CENTER-COX SUBDIVISION

APPLICATION NUMBER 8 DATE September 20, 2007

REQUEST Subdivision

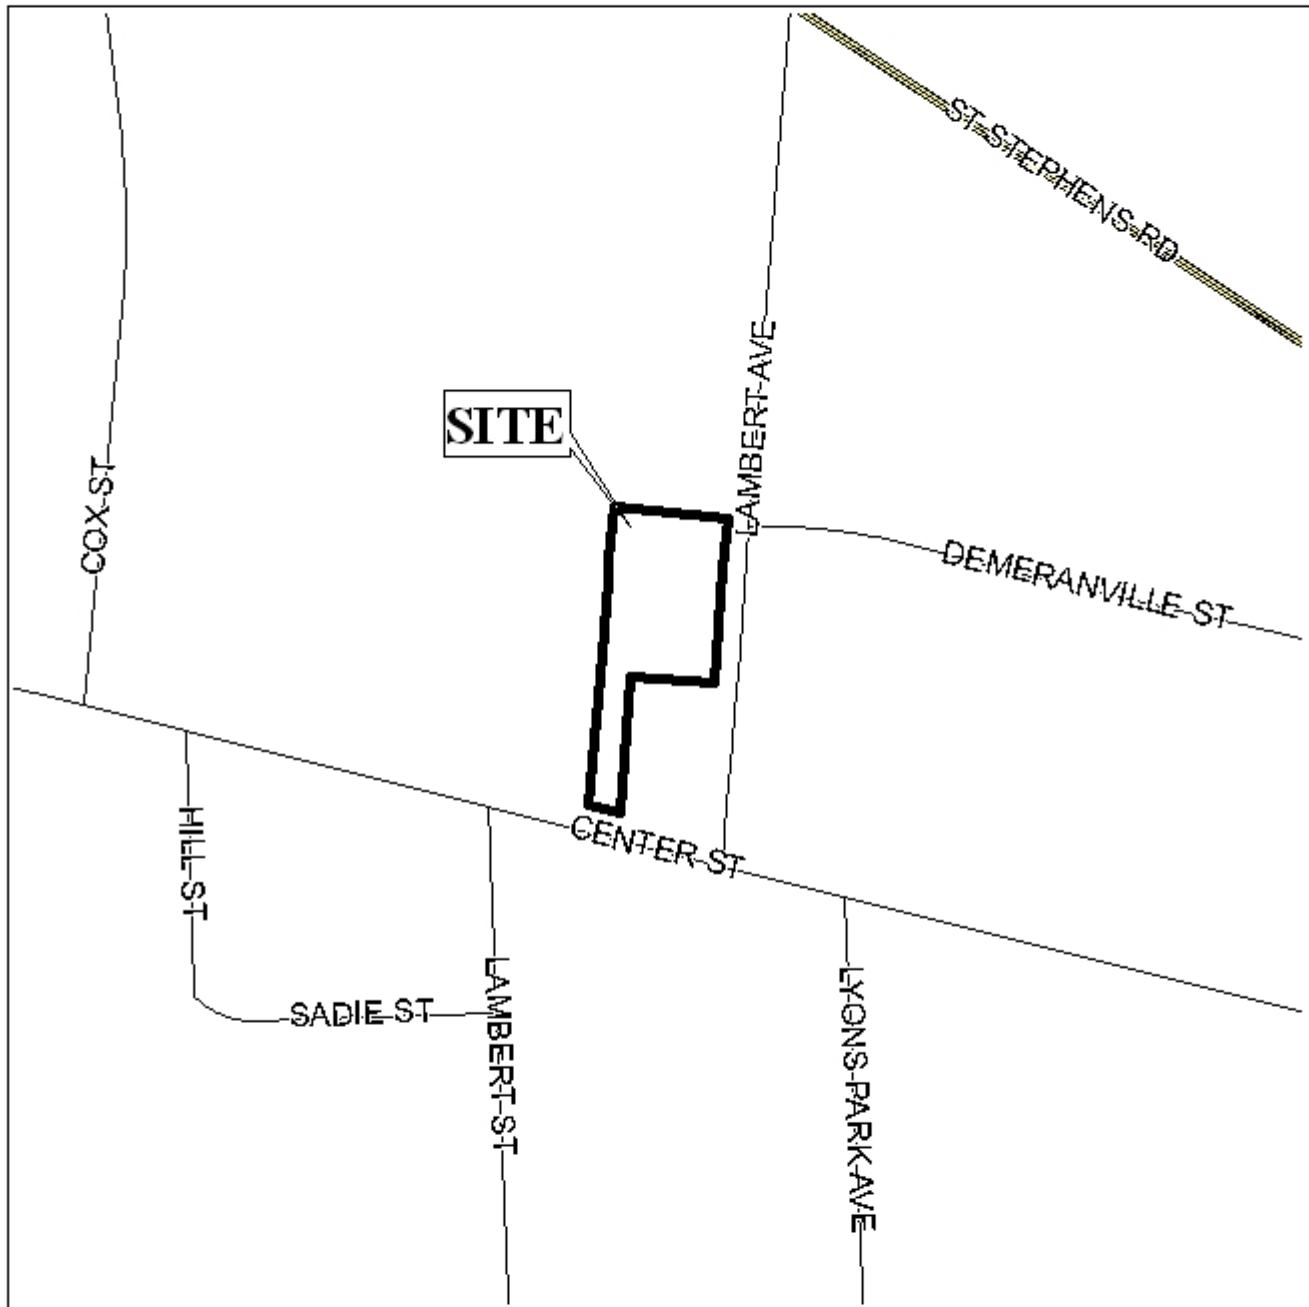
Since the site has approx. Thirty-nine linear feet of frontage along Center Street and 169 linear feet of frontage along Lambert Avenue.; a note should be placed on the final plat stating that the site is limited to one curb cut to each street, with the size, location and design to be approved by Traffic Engineering and conform to AASHTO standards.

There is no depiction of the minimum 25ft building setback from Center Street. While the owner of the property, The University of South Alabama, may be exempt from our subdivision regulations, the setback should still be shown for other potential owners.

1. the depiction on the final plat of the 25' front setback line along Center Street;
2. placement of a note on the final plat stating that the site is limited to one curb cut on each street, with the size, location, and design to be approved by Traffic Engineering, and conform to AASHTO standards.
